APPLICATION NUMBER - SSD-67175465

Site 173-179 Walker Street and 11-17 Hampden Street, North Sydney
Objector Dixon ANDREWS
Date 30/7/2024

The diagram shown on Page 38 of the report is from the a DPE report that copied the diagram from the visual impact statement from the applicant’s submission for PP-2020-141.

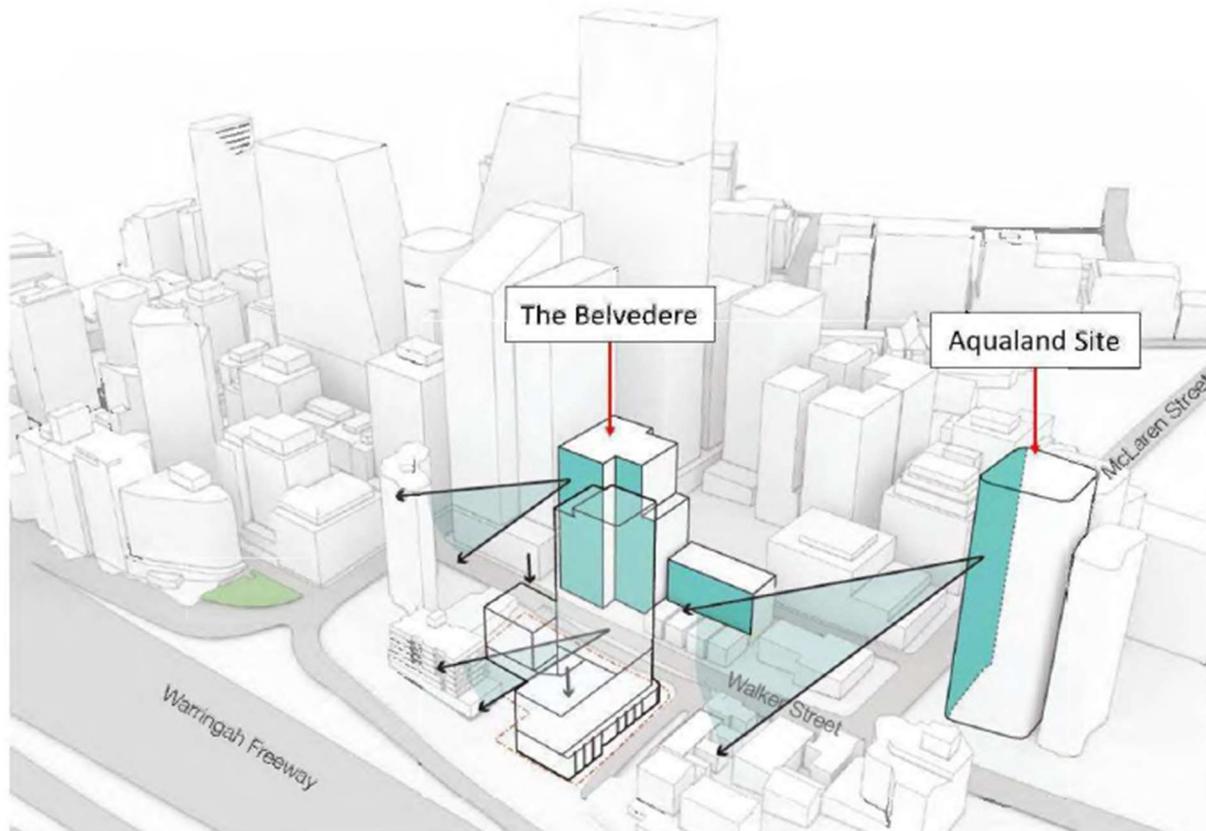
The diagram completely ignores the impact of the proposal on all the buildings along Miller St and the affected building in McLaren St other than on section of the Aurora building. This is a

clear demonstration of the flawed nature of the reports used to justify the approval of PP-2020-141

I am surprised that this diagram has been included in the current report given the inadequacy of the diagram itself and the inherent inadequacies in the conclusions based on it.

Any conclusions drawn from this diagram are invalid.

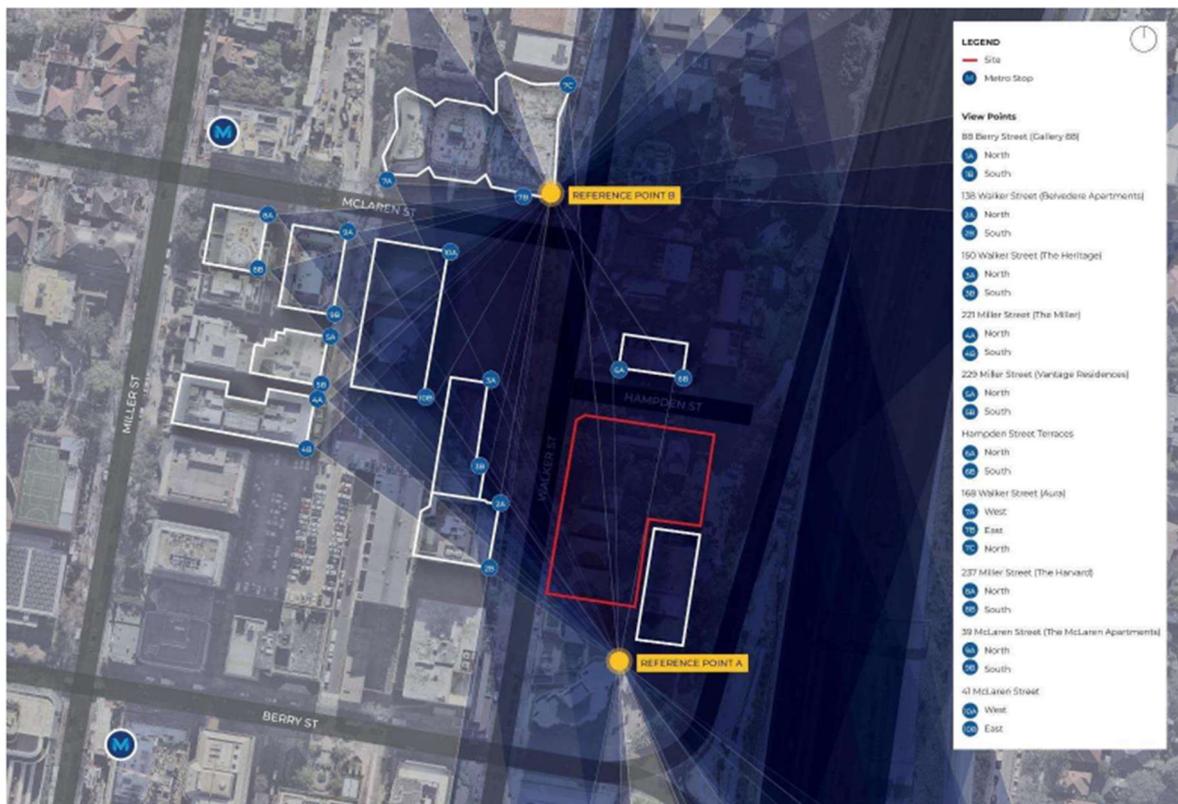
In all but a few of the cases the view assessment has been made from a balcony not from within the apartment. This deliberately misrepresents the actual view loss for the residents of the apartments.

This approach is invalid under Tenacity. The impact on views has to be assessed from the whole of the property not from a location on the site that best suits the applicant.

The View Lines Map below is based on the locations of the photographs detailed in the report. As noted above these are predominantly taken from balconies and not from within the living areas of the apartments. As noted in Tenacity the location where views are obtained from must be established and view from living areas are to be considered to have a high level of significance.

The view lines shown in the diagram do not represent the view line from where the views are obtained from as required under the principles outlined in Tenacity and as a consequence the View Lines Map is invalid and any conclusions derived from it are also invalid.

The view lines attributed to the southeast corner of 229 Miller St (the location of our apartment) are fundamentally flawed. A simple site inspection will irrefutably verify this statement.
